COUNTY OF LOS ANGELES

DEPARTMENT OF PUBLIC WORKS

MODIFICATION OF STORMWATER OUTFALL MONITORING LOCATIONS FOR UPPER SAN GABRIEL RIVER COORDINATED INTEGRATED MONITORING PROGRAM

Figure 1 Original and Proposed Monitoring Locations for City of Industry

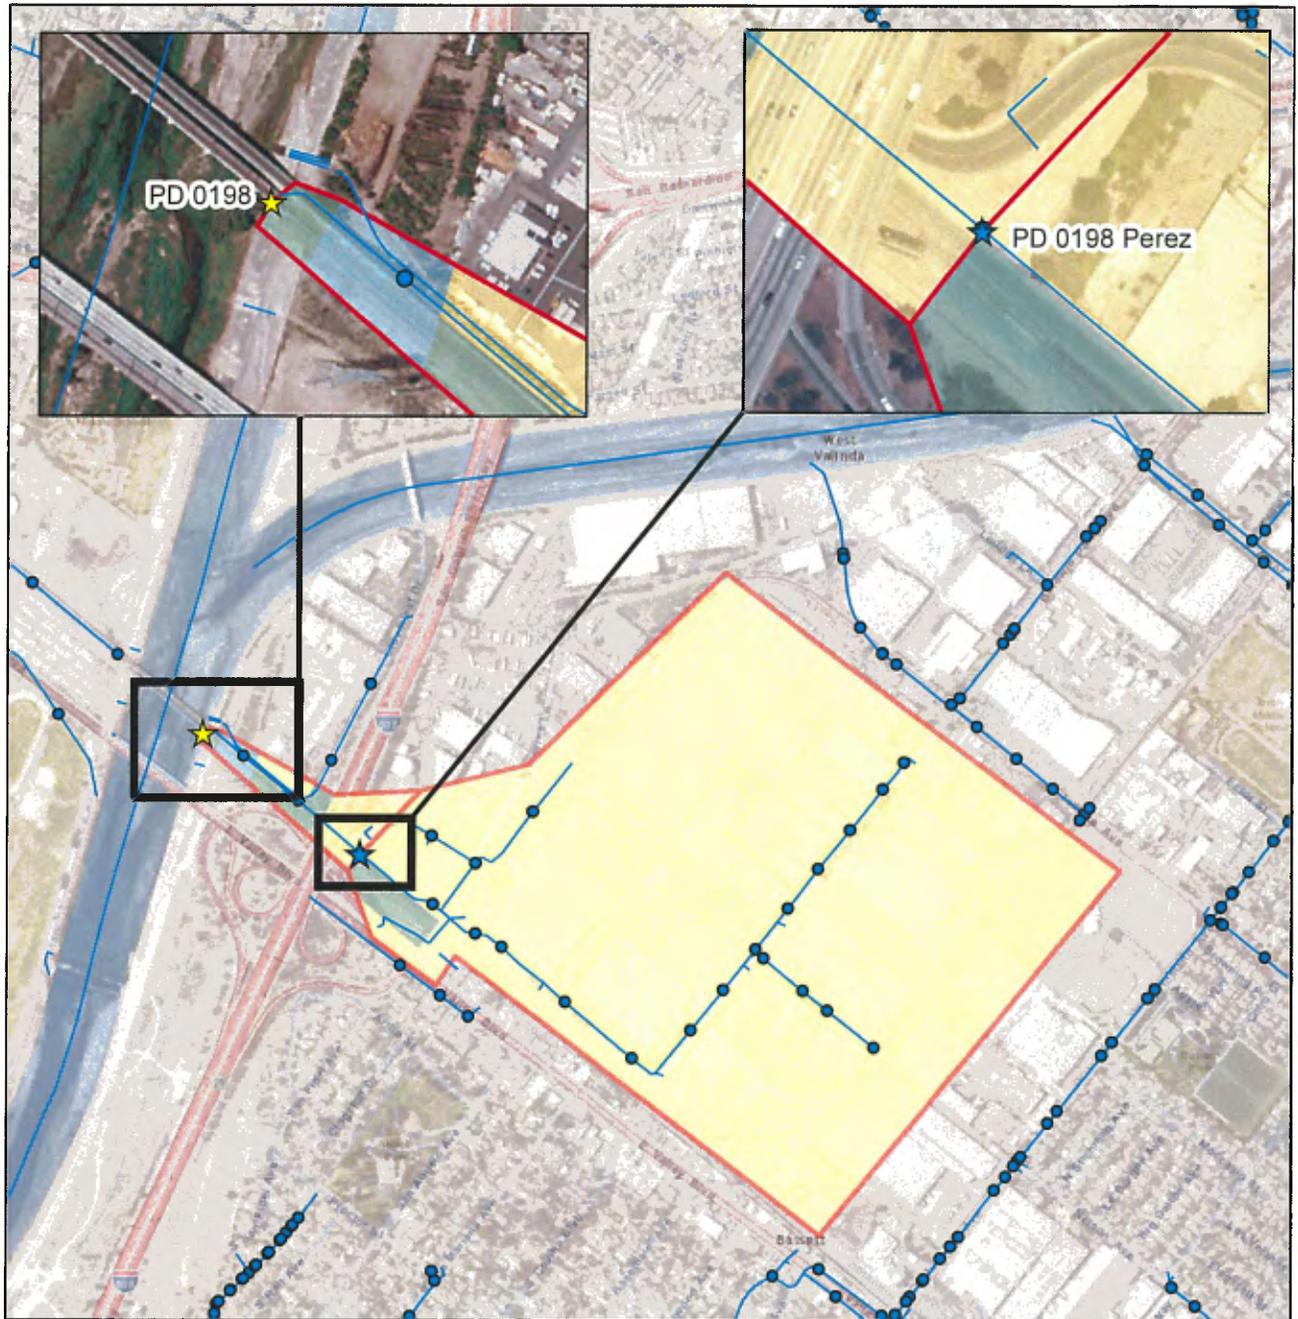
- Field Investigation Results of Stormwater Outfall Locations
 - Primary Location (BI 4301) – The outfall is located at the invert of the receiving water. As such, grab samples will result in co-mingled flows and not meet the requirements of outfall monitoring.
 - Alternate Location (Pellissier Place Drain) – It is not feasible to install self-charging solar panel monitoring equipment due to overgrown trees

near the monitoring location, which would obstruct the solar panel and rain gauge.

- Alternate Location (PD 0198) - The outfall has a flap gate, which does not allow for grab samples.
- Proposed Modification
 - PD 0198 Perez - The nearest feasible alternative monitoring site for PD 0198 is located at an upstream manhole within rail right of way (see Figure 1).
 - The proposed modification affects CIMP Table 4-1, Table 4-2, Section 4.2.4, Attachment B, and Attachment F.

Figure 2 Original and Proposed Monitoring Locations for County of Los Angeles

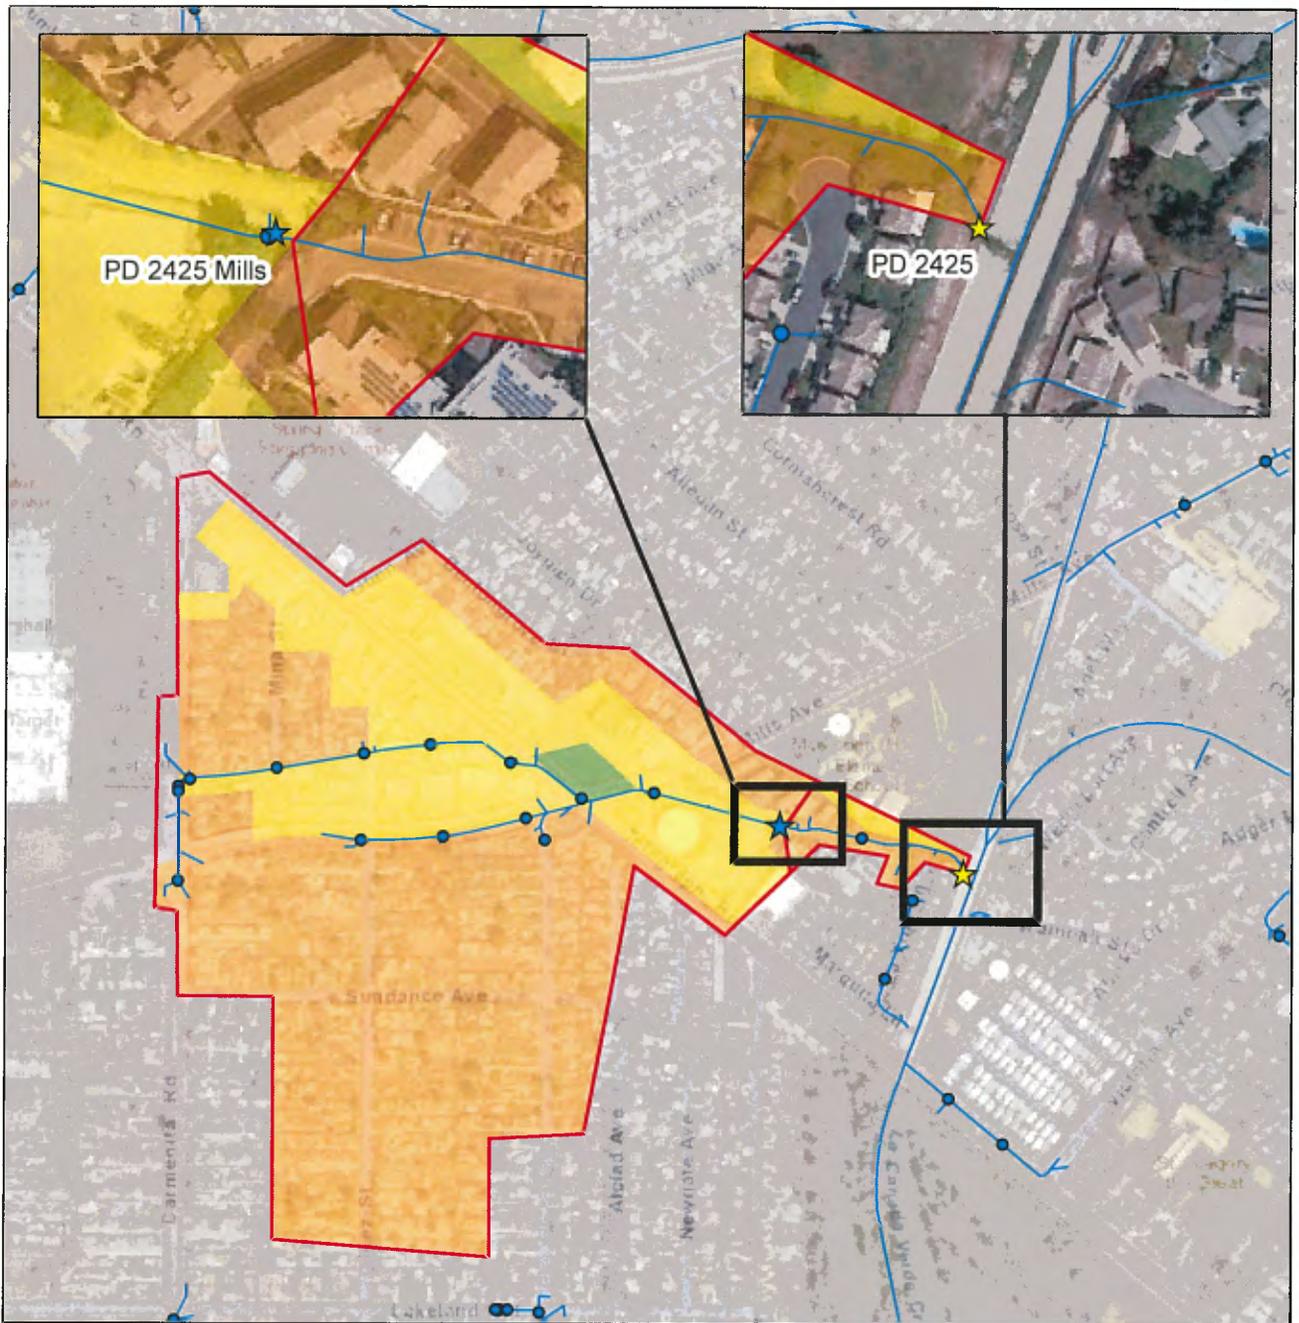
- Field Investigation Results of Stormwater Outfall Locations
 - Primary Location (PD 2425 Sorenson Ave Drain) - The outfall discharges about one foot above the invert of Sorenson Ave Drain, thus grab sampling is not feasible since it will result in co-mingled flows.
 - Alternate Location (BI 0531) – The outfall is located under a bridge, thus grab sampling is not feasible due to safety concerns. Since upstream manholes are located in the street, it is not feasible to conduct grab sampling activities due to safety concerns.
- Proposed Modification
 - PD 2425 Mills – An alternative monitoring location is proposed at the nearest feasible upstream manhole (see Figure 2).
 - The proposed modification affects CIMP Table 4-1, Table 4-2, Section 4.2.8, Attachment B, and Attachment F.
